New Castle Planning and Zoning Commission Regular Meeting

Staff Report

**Castle Valley Ranch PA 12
Sketch Plan
Planning Commission – February 14th, 2024**

Mixed Use Zoning - Phase 1

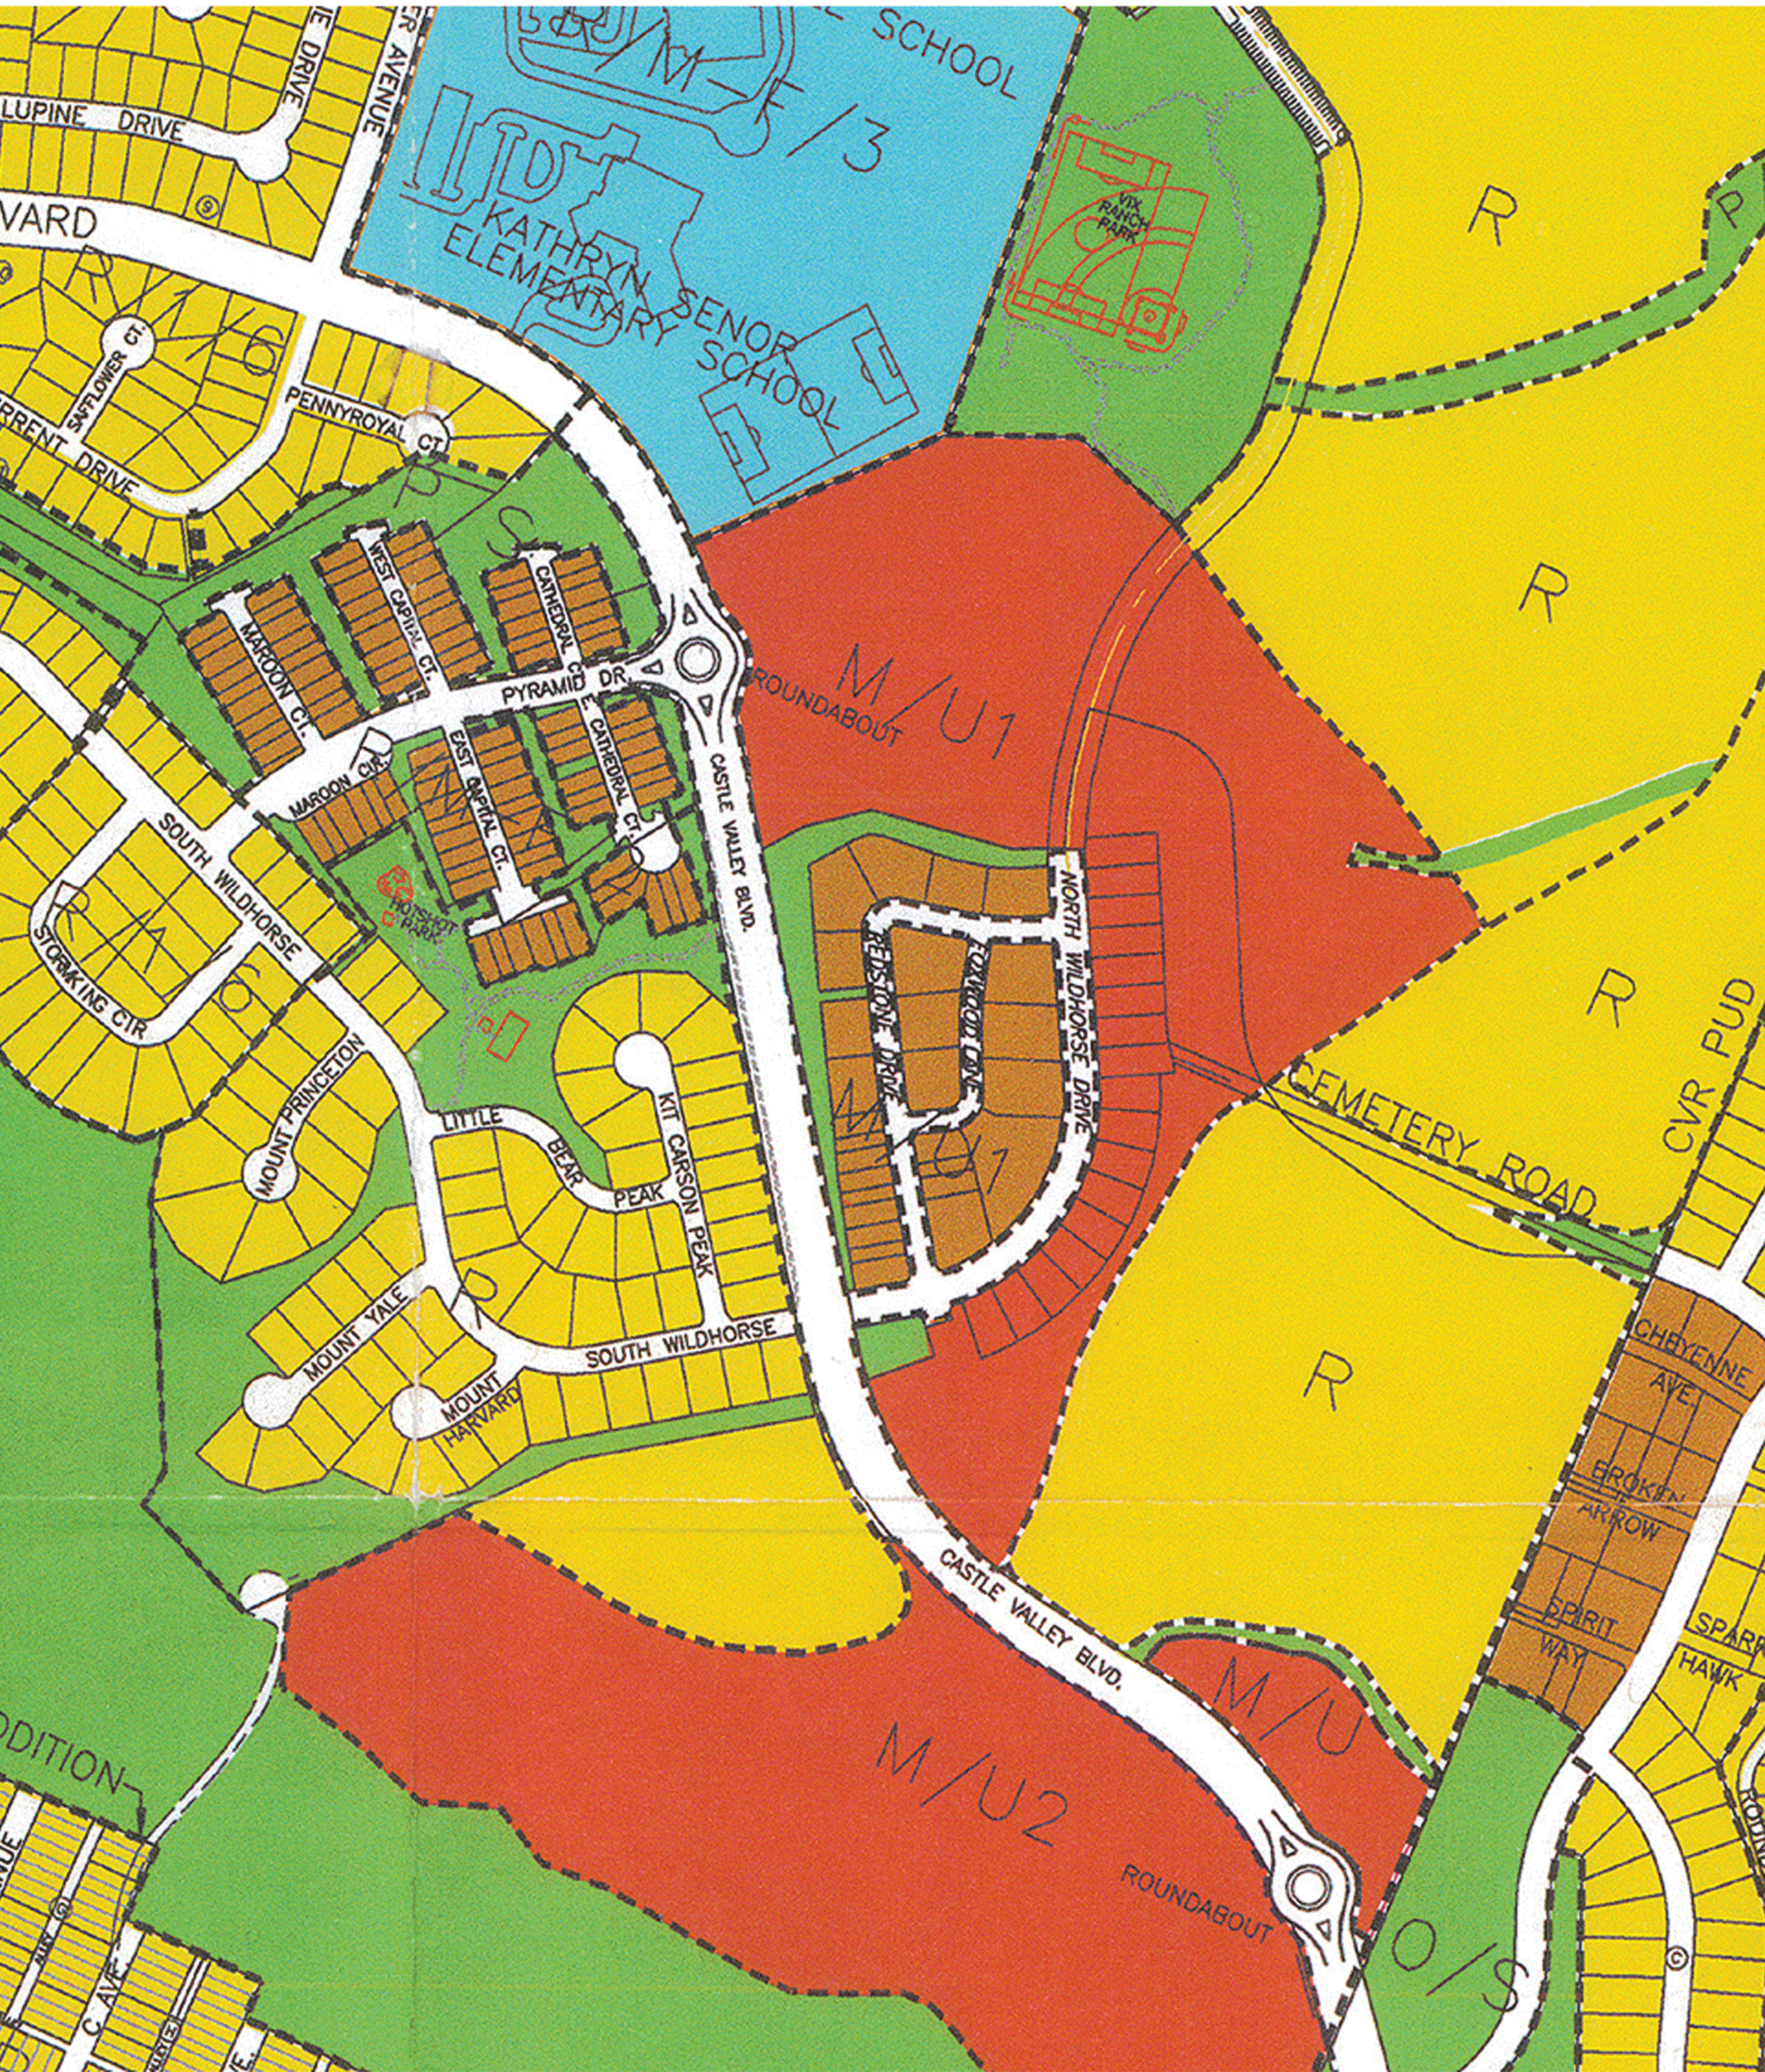
Off-Street Parking: Parking specifications and the parking plan for Phase 1 are prepared in **Exhibit A, pg. 5**. As designed, off-street parking is underrepresented by 10 spaces. The bulk of this deficit will be found in the restaurant parking lot(s) with a 17 space shortage. Patrons will likely be compelled to use empty bank or fueling station spaces when the nearer lots are full. EV supply equipment (EVSE) will also be required at a rate of one per lot or three total for Phase 1. Fueling bays are counted towards the parking total, a reasonable request given the nature of fueling stations. Pursuant to Section 17.104.100 (M), P&Z may approve joint use parking arrangements to allow parking from one lot to overflow to another during off-business hours (e.g. restaurant parking overflow to the bank parking lot during the evening). Ultimately, the purpose of off-street parking in the PUD “is to ensure that safe and convenient off-street parking is provided to serve the requirements of all land uses in the Castle Valley Ranch PUD and to avoid congestion in the streets” (MC 17.104.100). P&Z will need to consider whether the available parking proposed is commensurate with the commercial square footage envisioned.

Two way traffic through parking area; fire apparatus turn-around

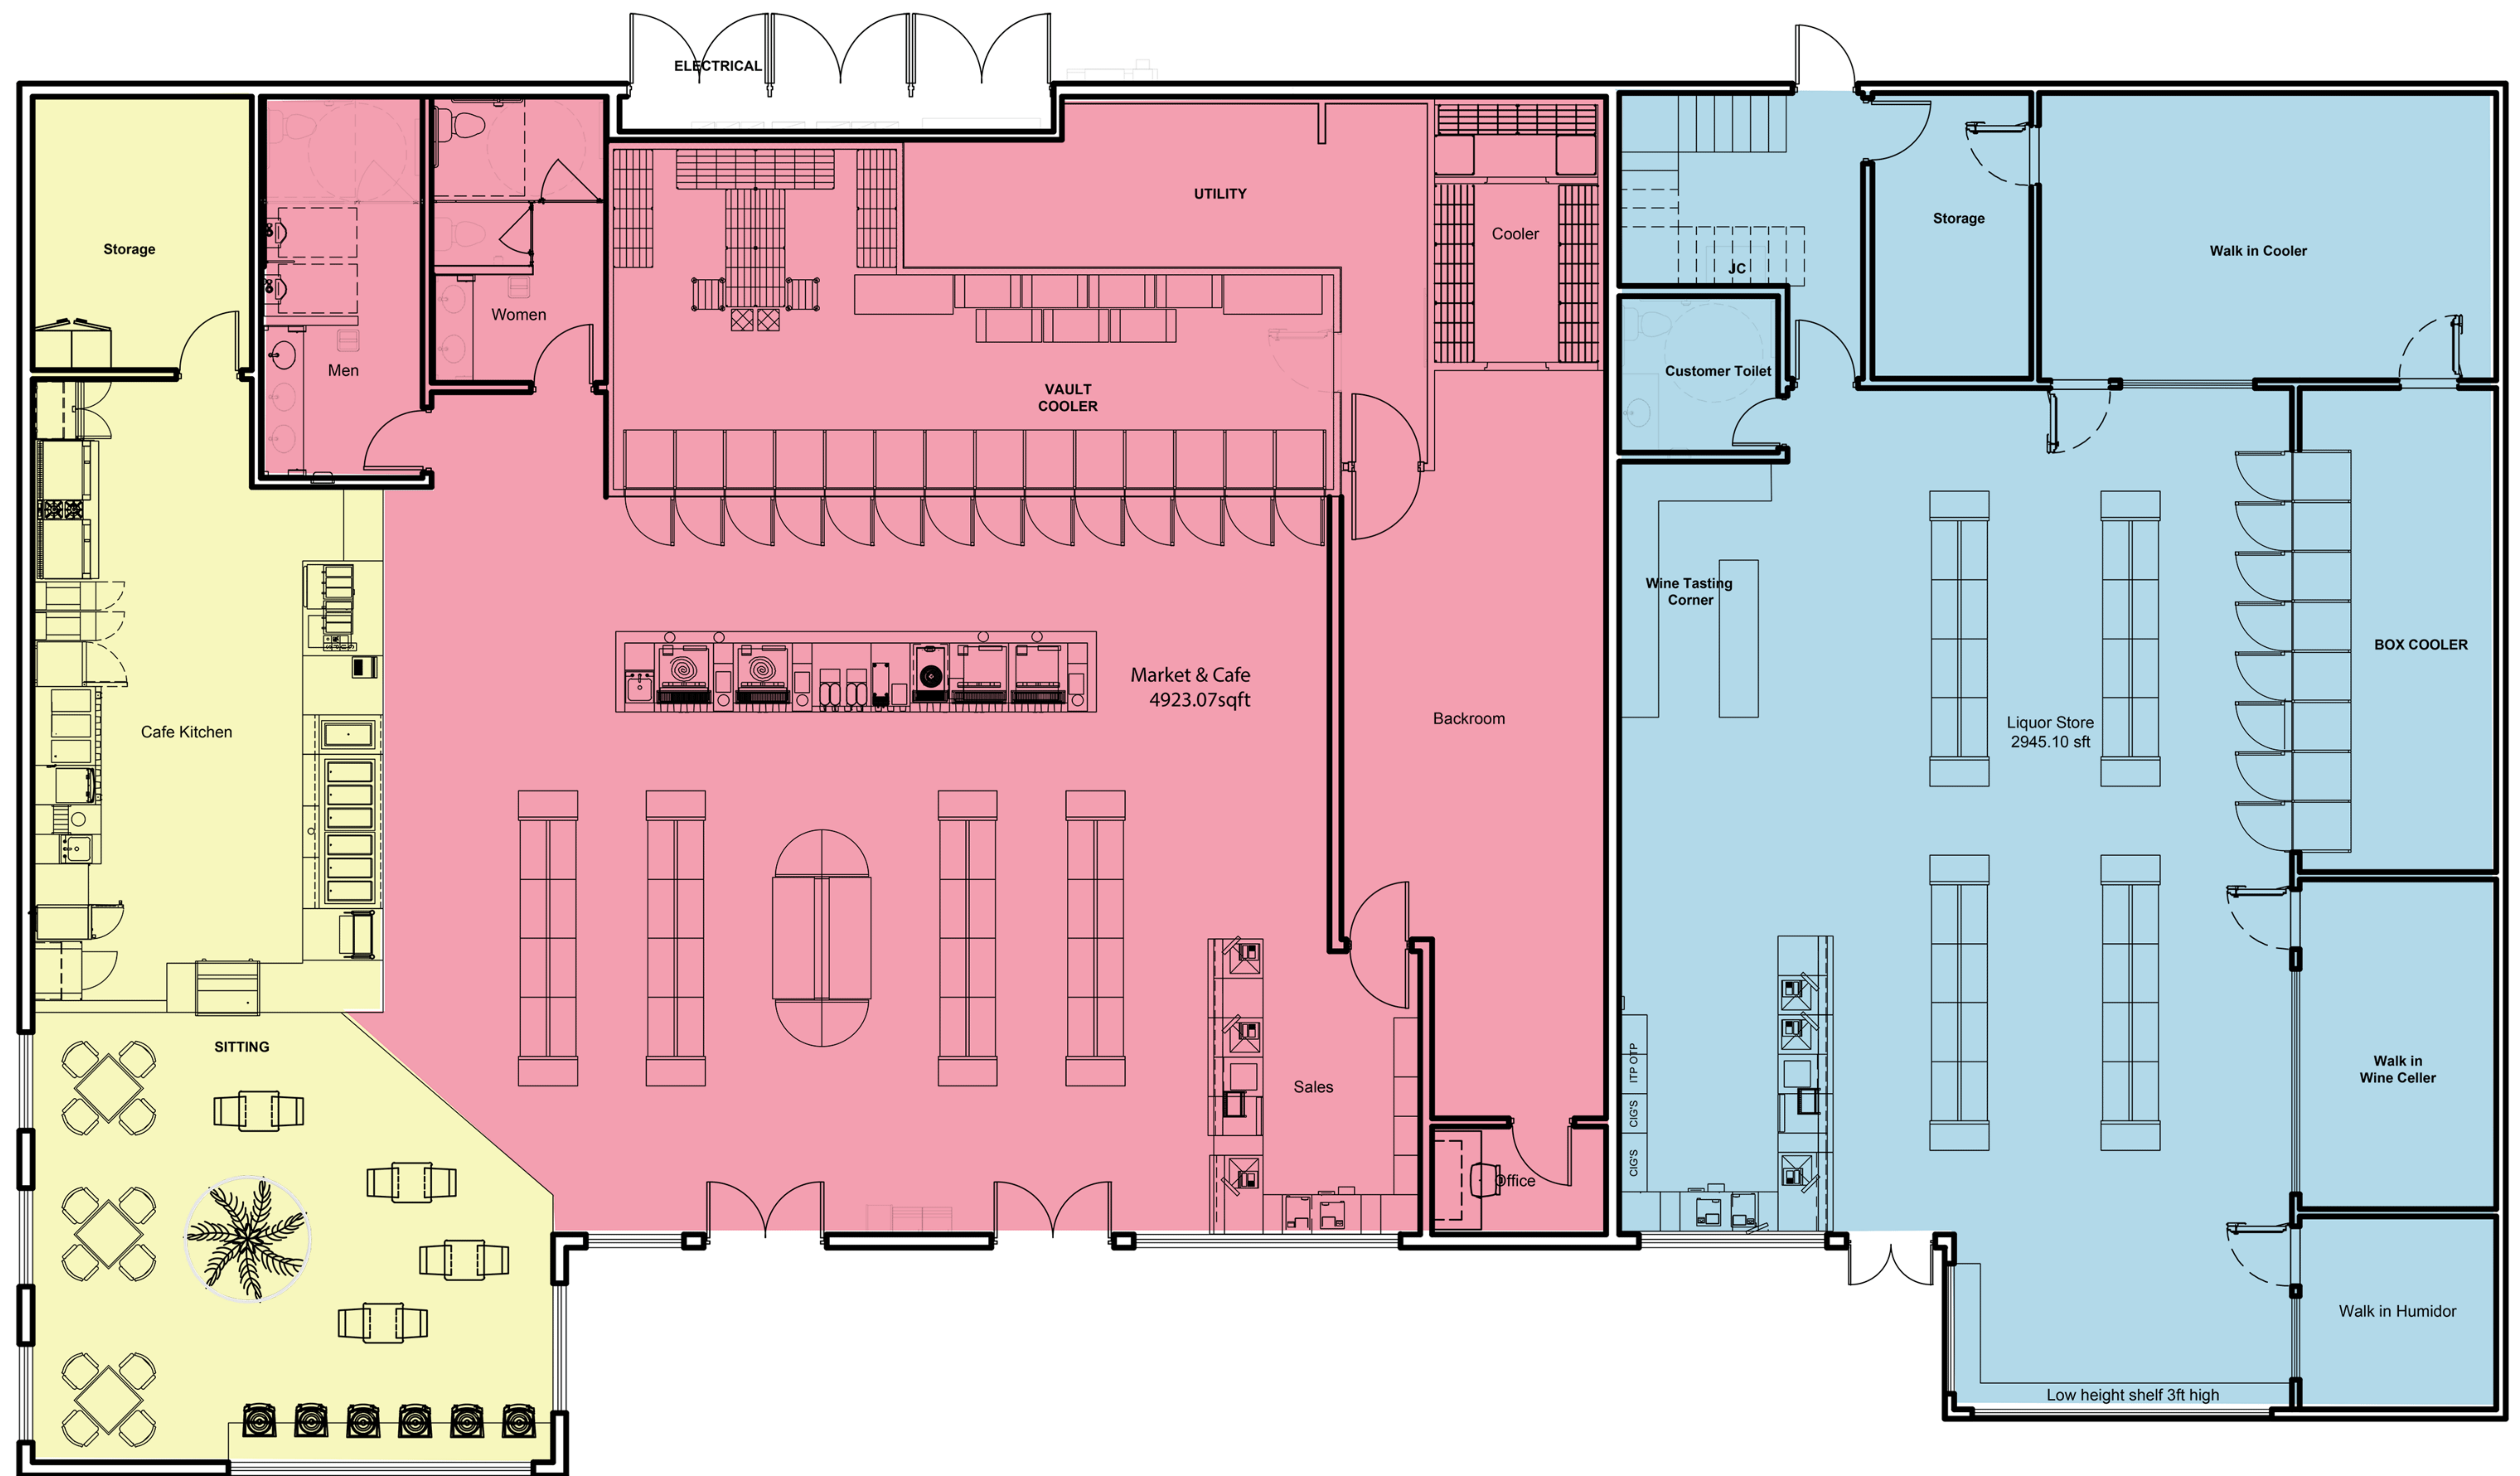
- D. Consider relocating all refuse containers (i.e. dumpsters) to the rear of buildings or out-of-sight of CVB.
- E. Provide temporary turnarounds for emergency personnel as recommended in the referral letter from CRFR.

1. Lot 1 and lot 2 at the end of the Phase 1 roadway shall have a fire apparatus turnaround installed until Phase 2 is built. All apparatus roads shall be designed and maintained to support the imposed loads of fire apparatus and surface shall be approved all weather driving surface.
